Access Compliance Report

Public Rights-of-Way

Intersection ID: 31960	Main Street: PORTER_PLACE_CT	Cross Street: SUNNY_GLEN_WY	Location: NE
ADA ID: F8D275E6C767	Ramp Type: PerpDiag	Initial Pass/Fail: Fail	Overall Compliance: No
			Severity Score: 21.25

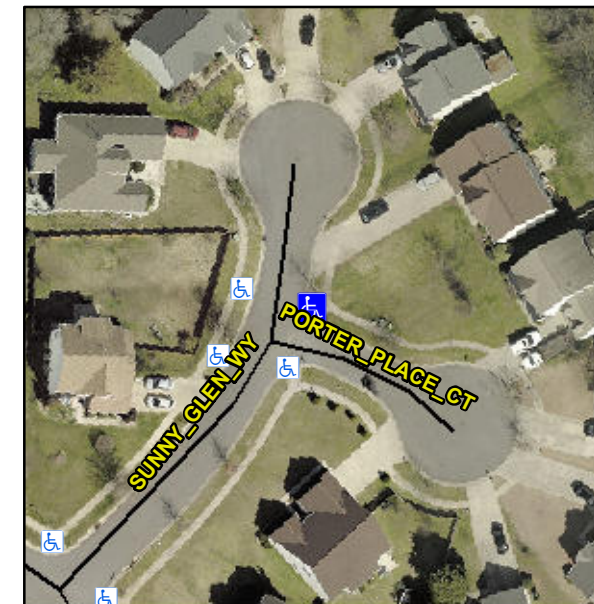
R304.5.1, R304.2.2

Compliance	Description	Data	Compliance	Description	Data
N/A	Ramp Length (in)	46.0	No	Ramp Slope (%)	10.2
No	Ramp Width (in)	39.0	Yes	Ramp XSlope (%)	0.9
N/A	Flare Type LT	N/A	N/A	Flare Type RT	N/A
N/A	Flare Slope LT (%)	N/A	N/A	Flare Slope RT (%)	N/A
N/A	Flare Traversable LT?	N/A	N/A	Flare Traversable RT?	N/A
N/A	Landing Length (in)	N/A	N/A	DWS Provided?	N/A
N/A	Landing Width (in)	N/A	N/A	DWS Contrast?	N/A
N/A	Landing Slope (%)	N/A	N/A	DWS Length (in)	N/A
N/A	Landing X Slope (%)	N/A	N/A	DWS Full Width?	N/A
N/A	Landing Curb? (Y/N)	N/A	N/A	DWS Offset (in)	N/A
N/A	Shared Landing?	N/A			
N/A	Gutter Ponding?	N/A	N/A	Gutter Slope (%)	N/A
N/A	Gutter Lip Ht (in)	N/A	N/A	Gutter X Slope (%)	N/A
N/A	Painted X Walk1?	No	N/A	Painted X Walk2?	No
	X Walk 1 Direction	To NW		X Walk 2 Direction	To SW
N/A	X Walk 1 Width (in)	N/A	N/A	X Walk 2 Width (in)	N/A
	X Walk 1 Slope (%)	3.2		X Walk 2 Slope (%)	0.1
	X Walk 1 X Slope (%)	0.3		X Walk 2 X Slope (%)	0.0

Remove & Replace Curb Ramp With Two New Directional Ramps or Equivalent.
